STAFF RECOMMENDATION
1407 Eastland Avenue
January 20, 2016

Application: New construction-detached accessory dwelling unit (DADU)
District: Lockeland Springs-East End Neighborhood Conservation Zoning Overlay
Council District: 06
Map and Parcel Number: 08305037500
Applicant: Jim Rodgers, JDR Design Group
Project Lead: Paul Hoffman, paul.hoffman@nashville.gov

<p>Description of Project: The applicant proposes to build a detached accessory dwelling unit with a nine hundred and ninety-five square feet (995 sq. ft.) footprint at the rear of the lot.</p> <p>Recommendation Summary: Staff recommends approval of the application with the conditions:</p> <ol style="list-style-type: none">1. Staff approve the windows, doors and garage doors;2. Staff approve the roofing color; and,3. The applicant file a restrictive covenant, acknowledging that the detached accessory dwelling is being established accessory to a principal structure and may only be used under the conditions listed in section 17.16.030.F of the Code. <p>Meeting these conditions, Staff finds that the project meets Section 17.16.030.F of the Metro Code, and the design guidelines for the Lockeland Springs-East End Neighborhood Conser

SECOND FLOOR PLAN
SCALE: 1/4" = 1'-0"

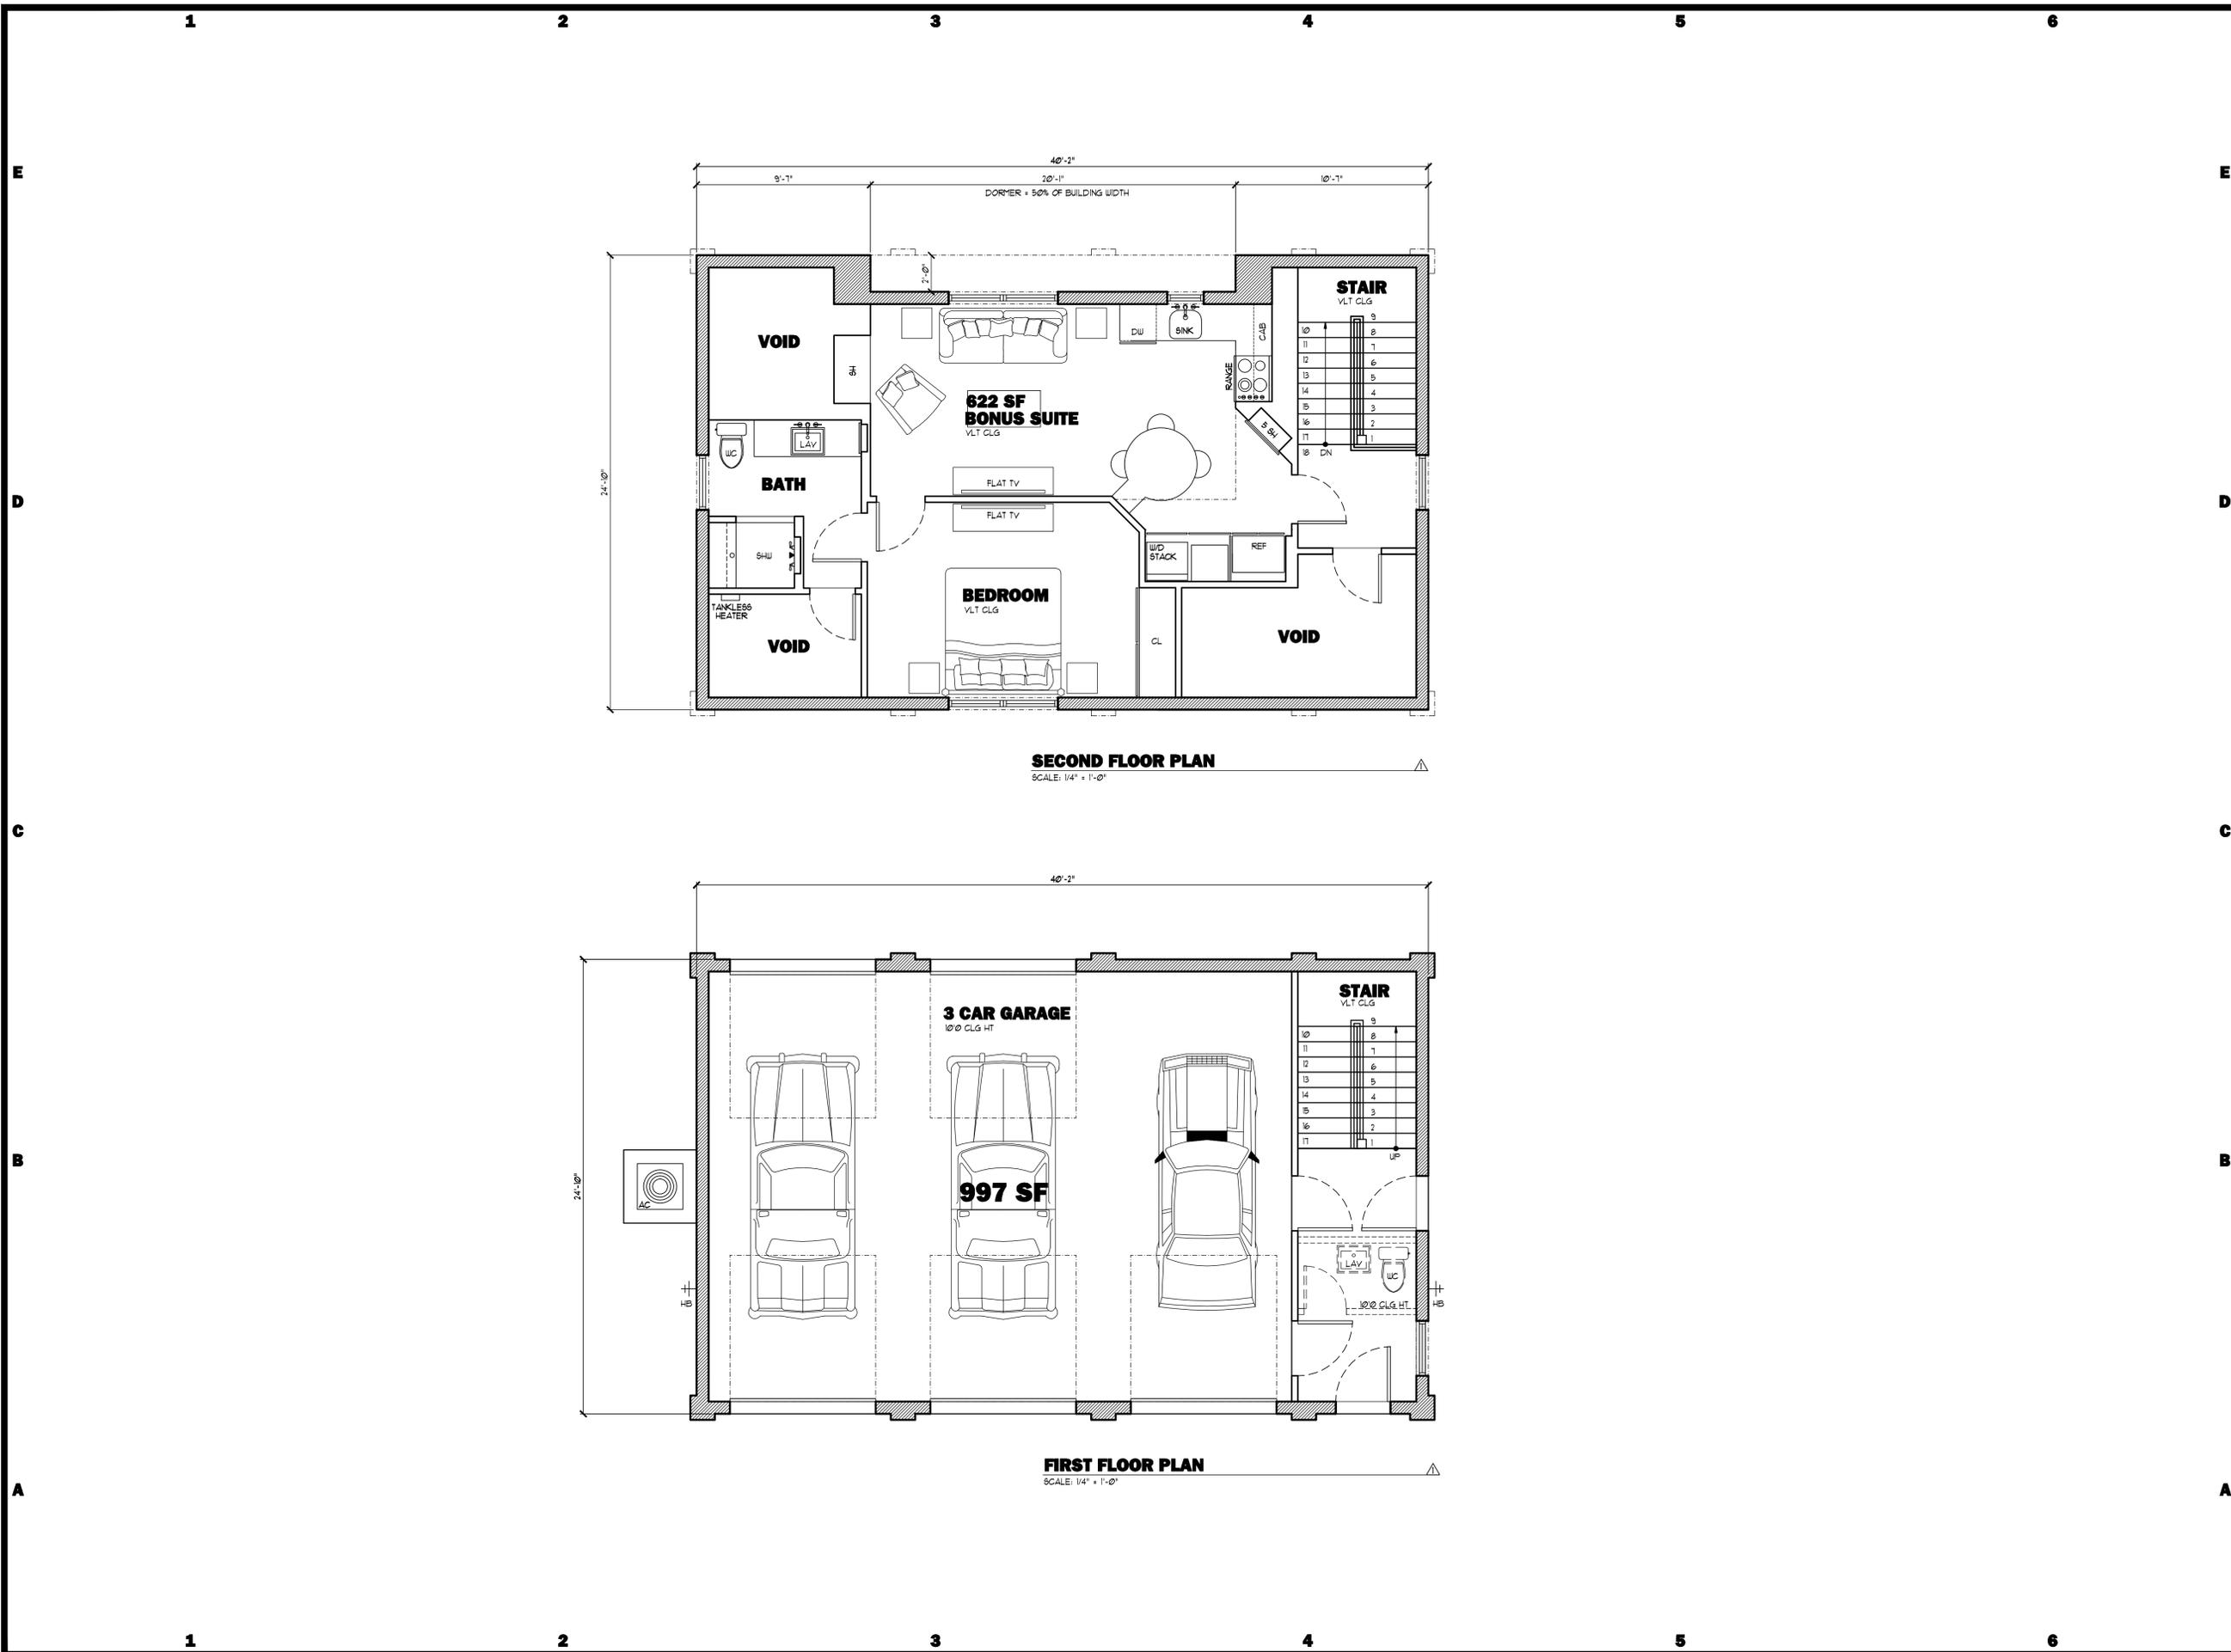
Height/Scale: The proposed outbuilding is one-and-a-half stories and has a footprint of nine hundred and ninety-five square feet (995 sq. ft.). The ridge height is proposed at twenty-five feet (25'), with an eave height of ten feet (10'). The ridge height of the house is thirty-one feet (31'). The eave height and ridge height are appropriate.

Materials: The primary cladding will be wood or fiber-cement siding with a reveal matching the house. The gable fields will be clad in shakes.

1. Staff approve the windows, doors and garage doors;
2. Staff approve the roofing color;
3. The applicant file a restrictive covenant.

SITE PLAN
 SCALE: 1/8" = 1'-0"

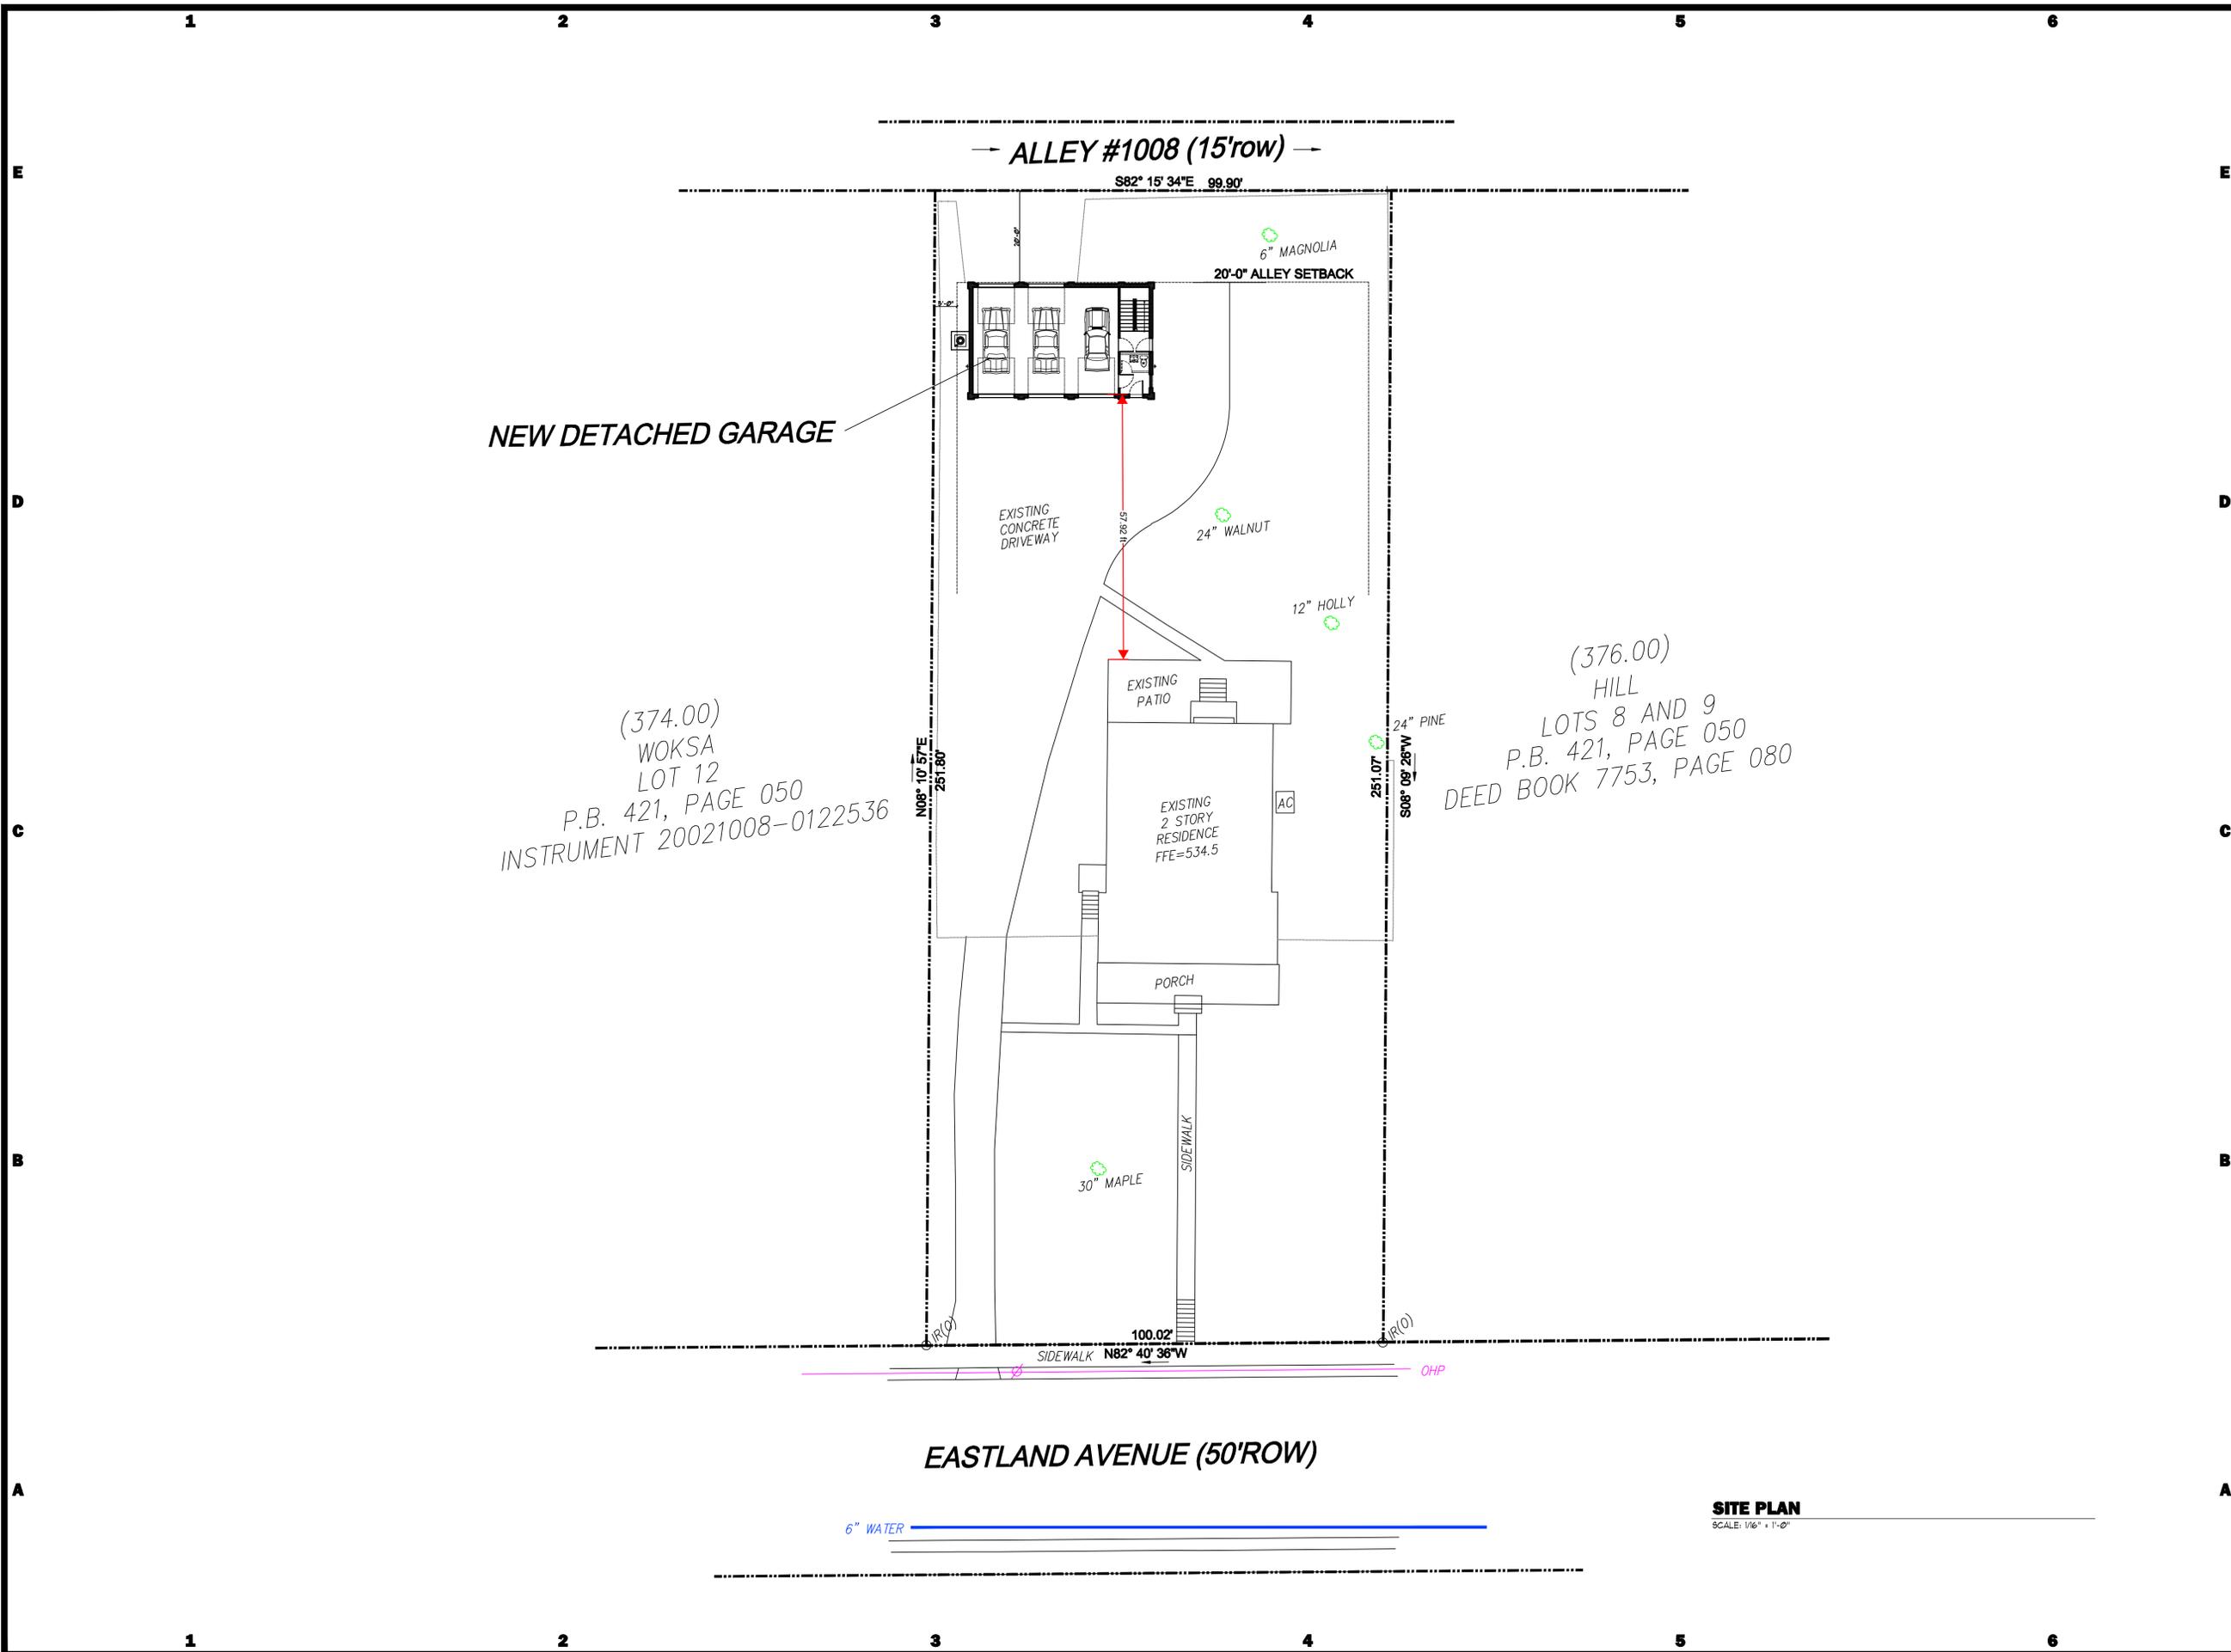
Location, Setbacks: The location is at the rear of the lot, accessed from the alley. The rear setback will be twenty feet (20'), so no setback determination is required.

PROPOSED	MINIMUM
Space between principle building and DADU/Garage	24’	20’
Rear setback	20’	3’
L side setback**	5’	3’
R side setback**	55’	3’
How is the building accessed?	ALLEY	From the alley or existing curb cut
